REVISED ASSESSMENT REPORT

Section 75W Modification

Trinity Point Mixed Use Development (MP06_0309 MOD 2)

Figure 3: Concept Plan Marina Layout as Proposed Pursuant to Term B1

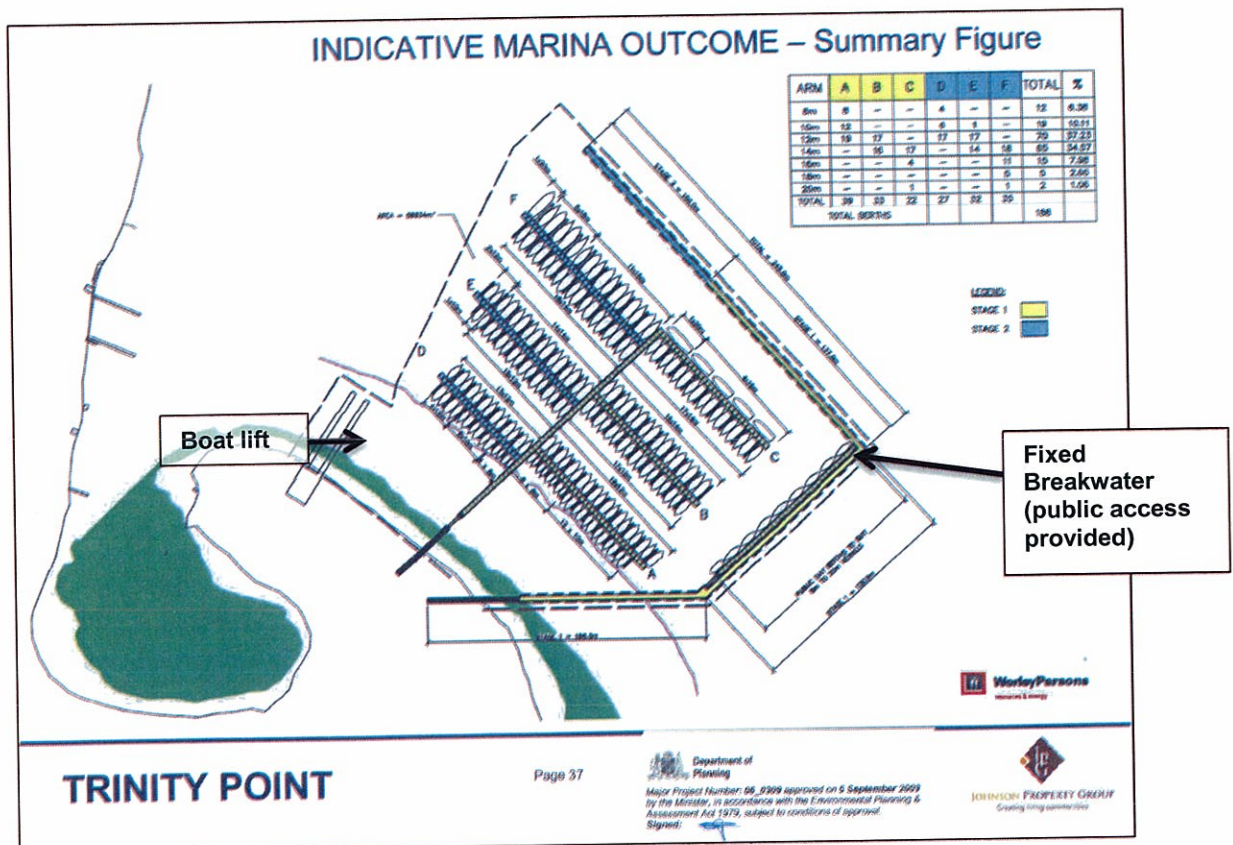
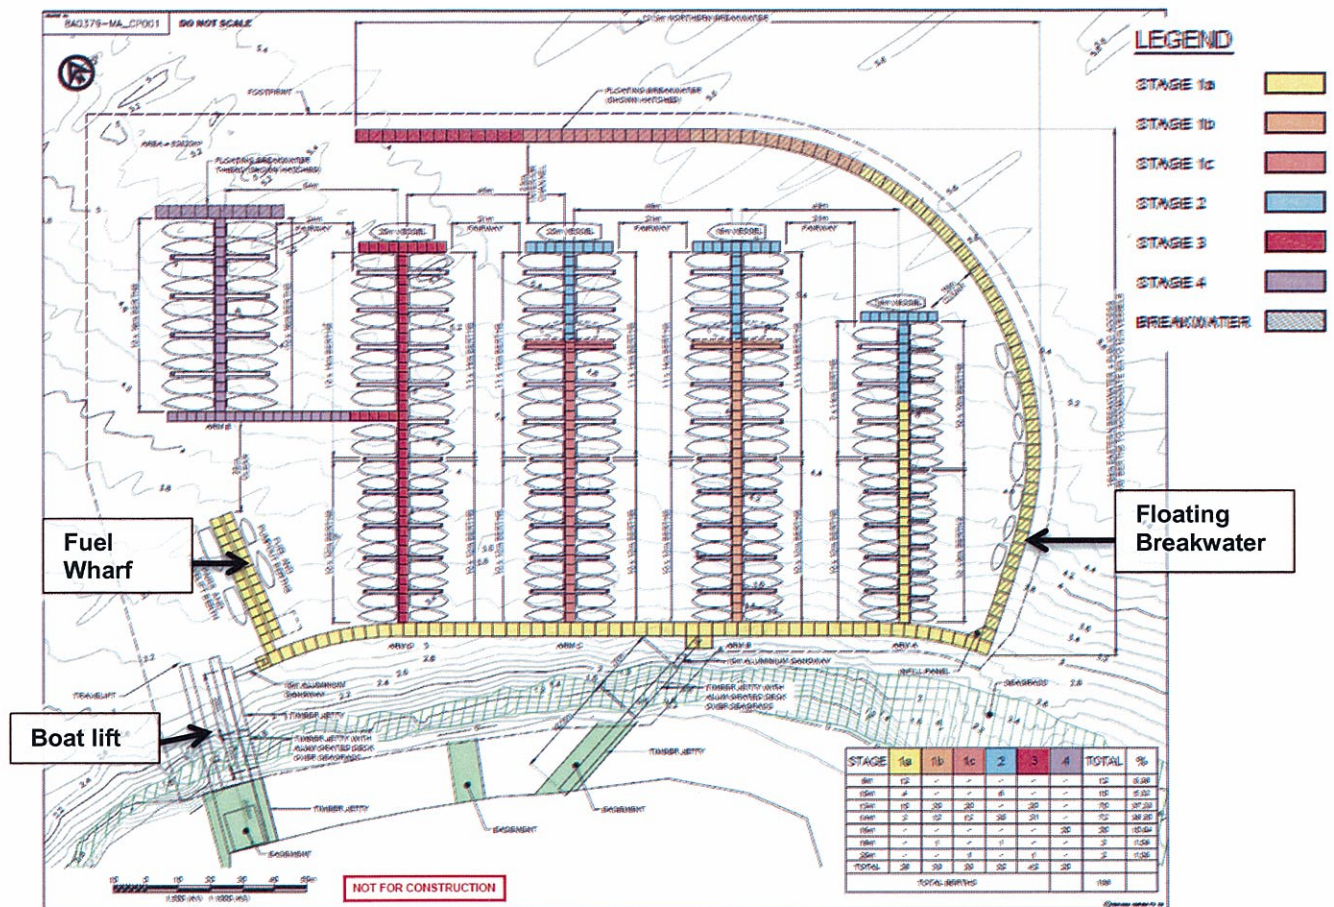
It is noted that the revised layout approved under Term B1 did not specify whether public access would be provided along the breakwater. A comparison of the original Concept Plan and the layout proposed to satisfy the requirements of Term B1 of the Concept Plan is provided in **Figures 2 and 3** below.

The Department assessed the proposed revisions to the marina layout and concluded that the revised design satisfied the performance criteria outlined in Term B1 for the following reasons:

Figure 5: Comparison of Marina Original Marina Layout (grey), Marina Layout as Approved under Term B1 (yellow), and Proposed Marina Layout (red)

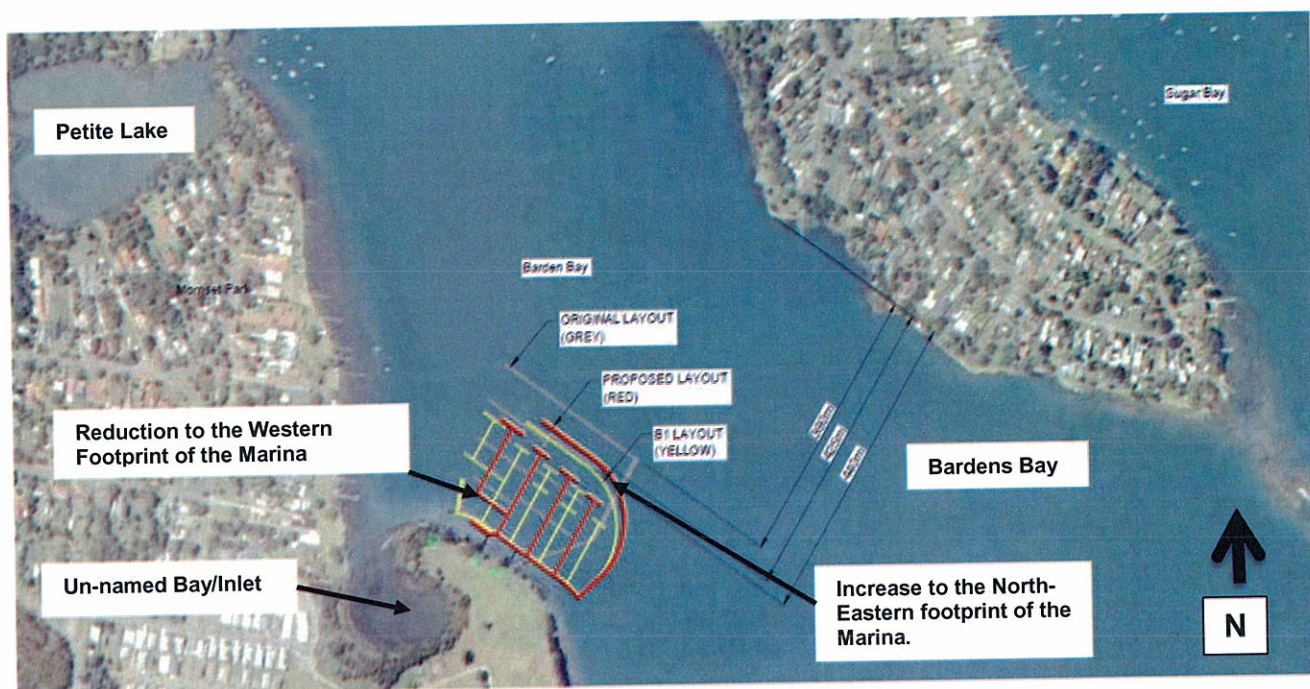
The Department has reviewed the Council's comments and notes that the marina will extend an additional 15 m in a north-easterly direction into Bardens Bay from its approved location.

However, the revised design will be reduced by approximately 30 m in a westerly direction away from residential areas (see **Figure 5** above) and the overall footprint will be reduced by approximately 1,530 m². The Department is satisfied that the revised layout will not result in additional visual impacts.

Figure 7: Proposed Public Access Arrangements

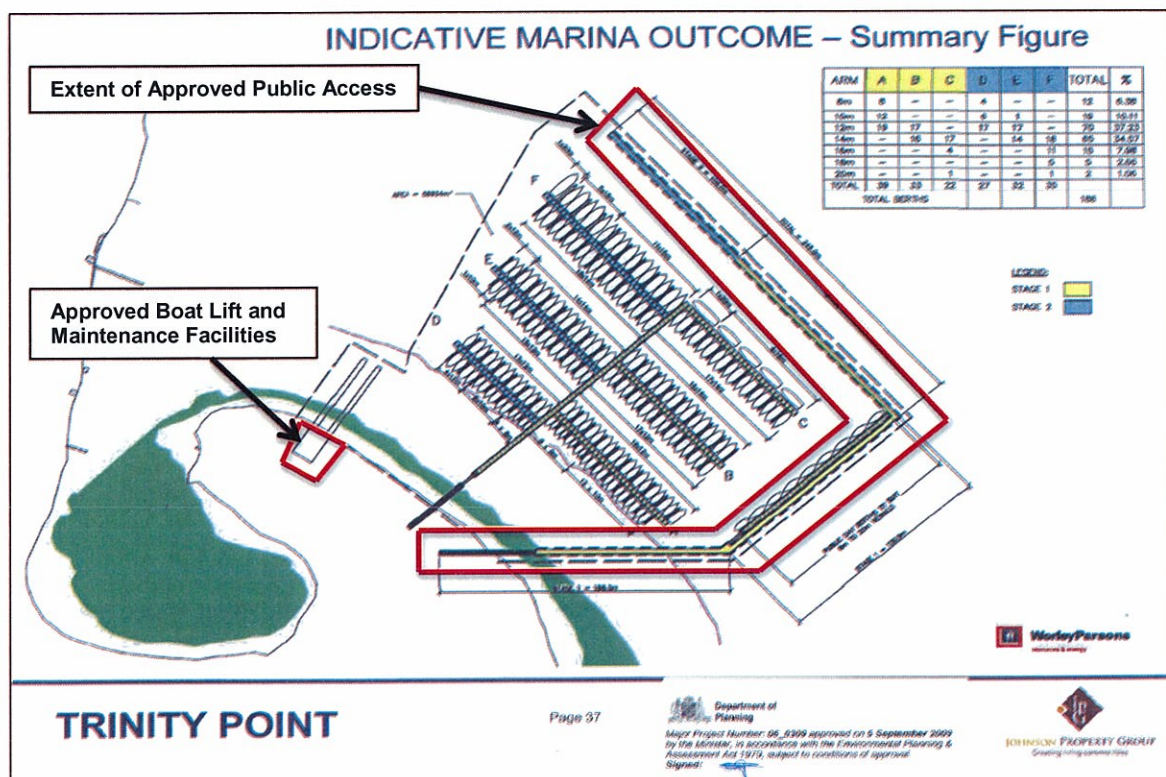
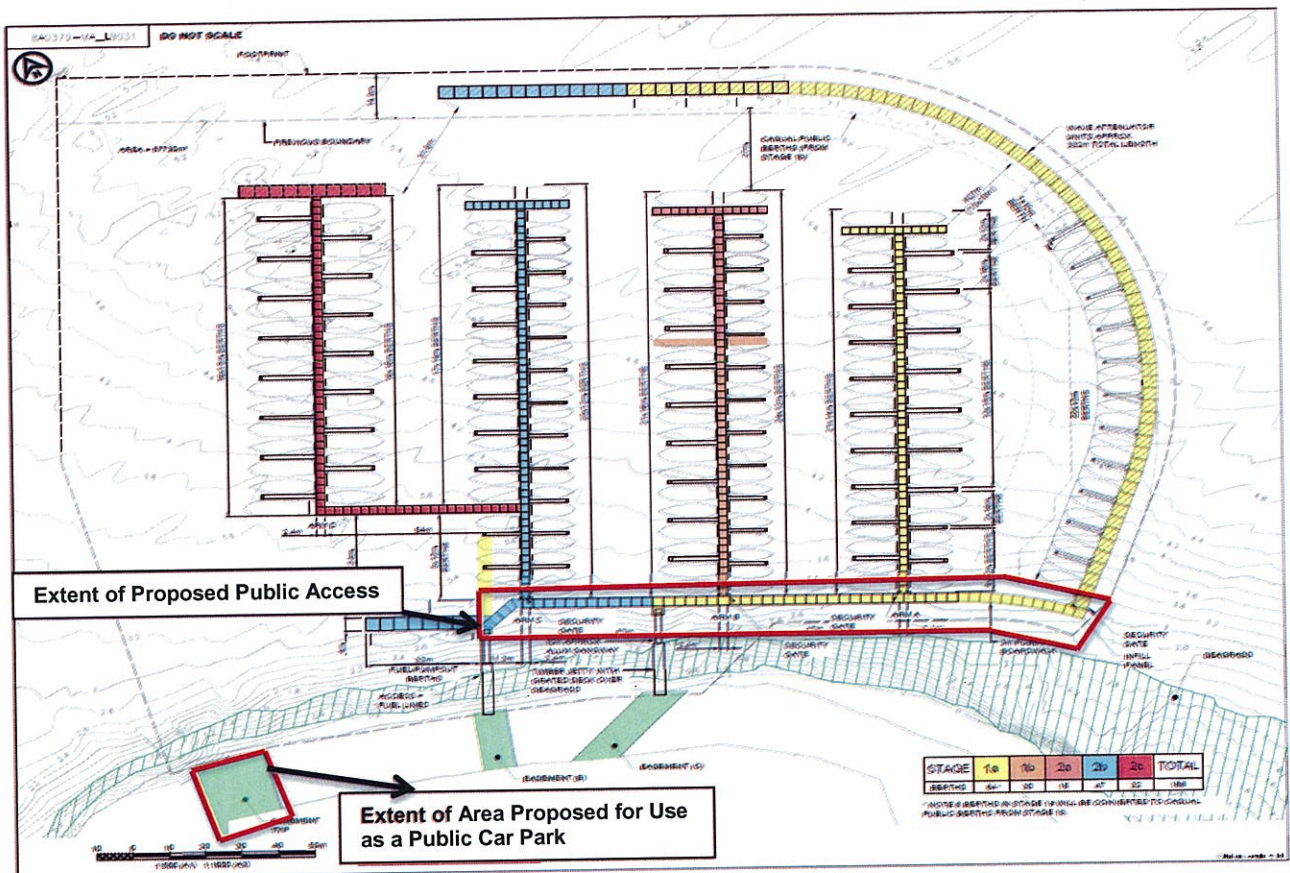
- remove public access along the floating breakwater for safety and security reasons;
- provide alternate public access along the floating pontoon boardwalk which runs parallel to the foreshore (See **Figure 7**); and
- convert the boat access and maintenance facilities to a car park.

The loss of public access along the breakwater was a major concern for Council and the local community. However, a submission from Crown Lands (the land owner) objected to public access being provided along the floating breakwater for safety and security reasons.

The Department acknowledges the concerns raised in submissions concerning the proposed reduction in public access. However, the Department notes that the modified design does not propose to fully exclude public access from the marina as the boardwalk located near the foreshore will be available for public access (see **Figure 7**).

The Department has reviewed the proposed modifications to the public access arrangements across the site and supports the proposed modifications on the basis that:

Overall, the Department's assessment concludes that public access along the breakwater is not supported due to public safety concerns, Crown lands (the land owner) not supporting the public access arrangements and as it is not standard practice for marina's to provide public access for safety and security reasons.

Figure 8: Proposed Location of 30 m Vessels within Stage 1B and Stage 2C of the Development

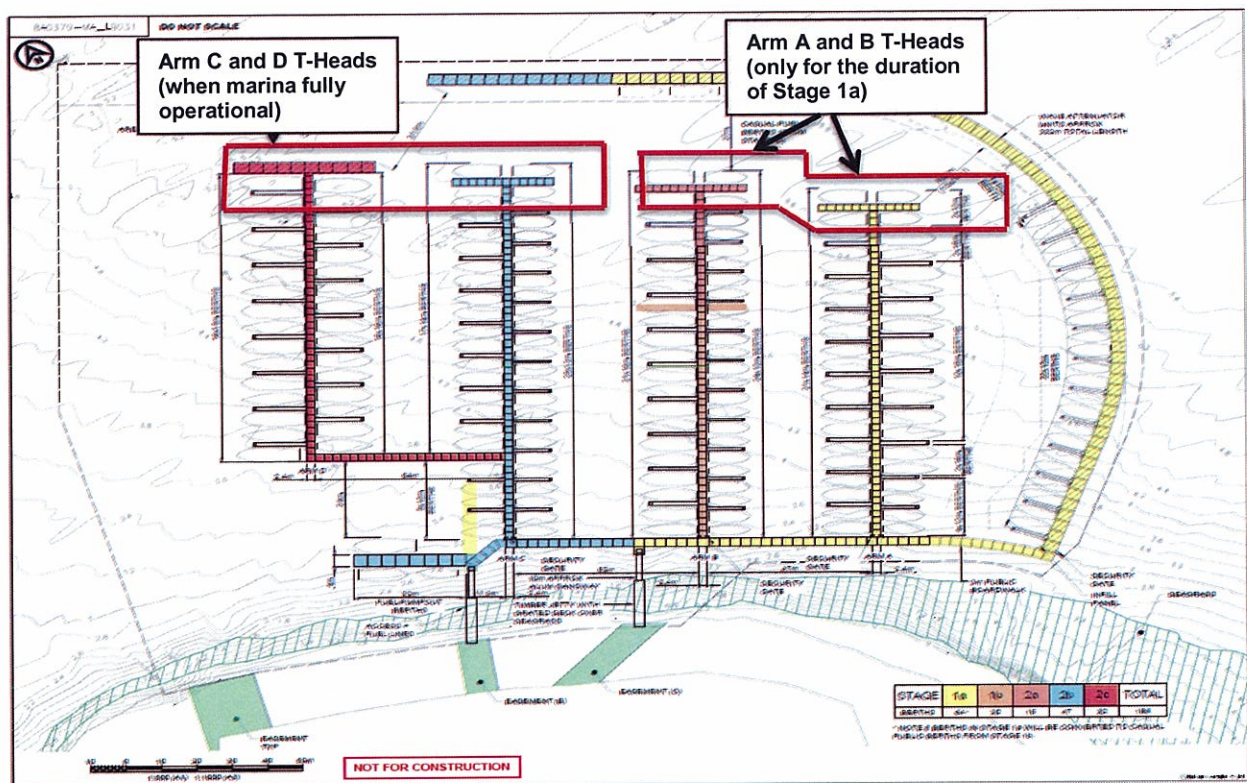
Subsequent to the lodgement of its RTS, the Proponent clarified that a maximum of two 30 m vessels are proposed to be berthed on-site, at any one time as follows (see **Figure 8** below):

- the temporary berthing of two 30 m vessels on the t-heads of arms A and B in Stage 1B until Stage 2 is completed; and
- following the completion of Stage 2, permanent berthing of two 30 m vessels will be provided on the t-heads of arms C and D.

Concerns were raised by both the Council and the local community regarding berthing of larger vessels due to the potential visual, navigation, amenity and environmental impacts associated with on-site dredging, as well as dredging within the Swansea Channel. It is noted that RMS raised no issues regarding the increase in vessel length.

Given the uncertainty about the long-term depth of the Swansea Channel, the Department considers that it would only be appropriate to permit the berthing of two 30 m power vessels on-site, unless an on-going dredging program is established that would enable the safe passage of 30 m yachts through the Channel in the future. It is also noted that yachts may have some difficulty navigating the fuel wharf. As such, the Department has recommended modifications to Principle 14 of the Concept Plan to permit the berthing of two 30 m power vessels at the marina. Yachts may be permitted at the marina if it can be demonstrated that appropriate mechanisms are in place to facilitate the safe passage of 30 m yachts through the Swansea Channel.
